**Technical change to IE-SW-PL10M-series  
(10-Port Fast/Gigabit Ethernet managed Switches)**

- PCN-number: PCN-PN48-20180906-00-A
- date of publishing: 6<sup>th</sup> September 2018
- revision number: A

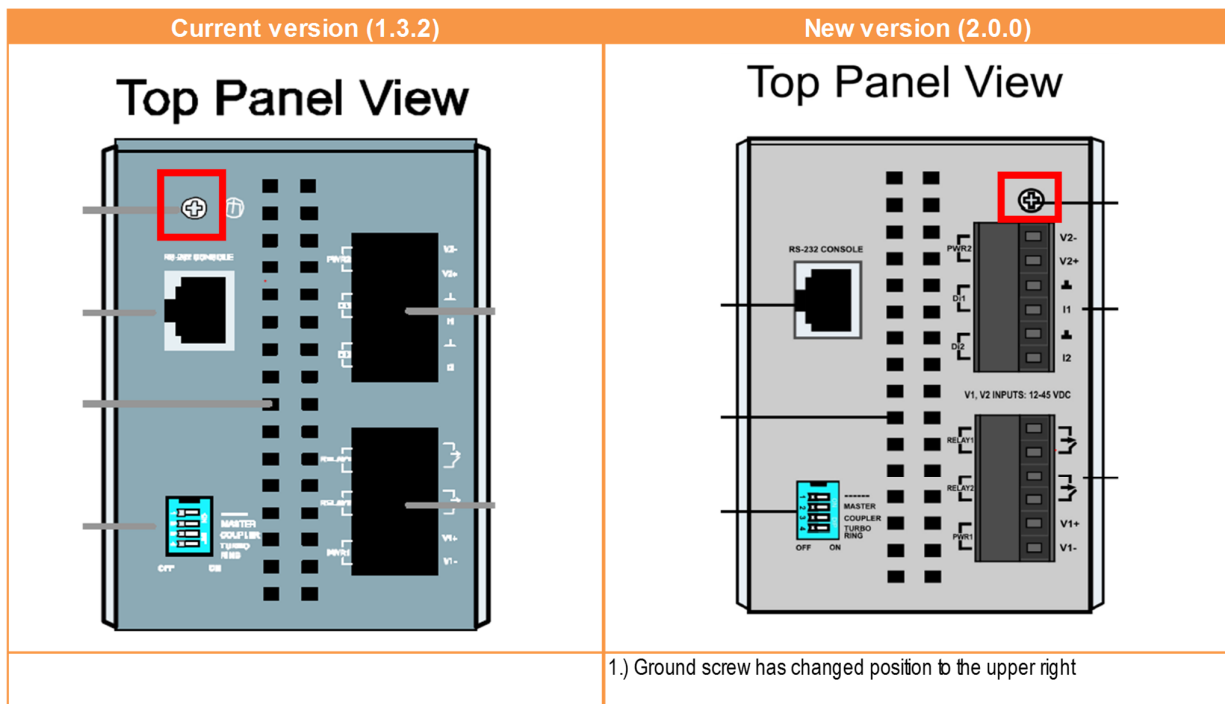
**2.) Position of ground screw at switch's top panel changed with new product version. Valid for products in table below. Refer to below figure for more details.**
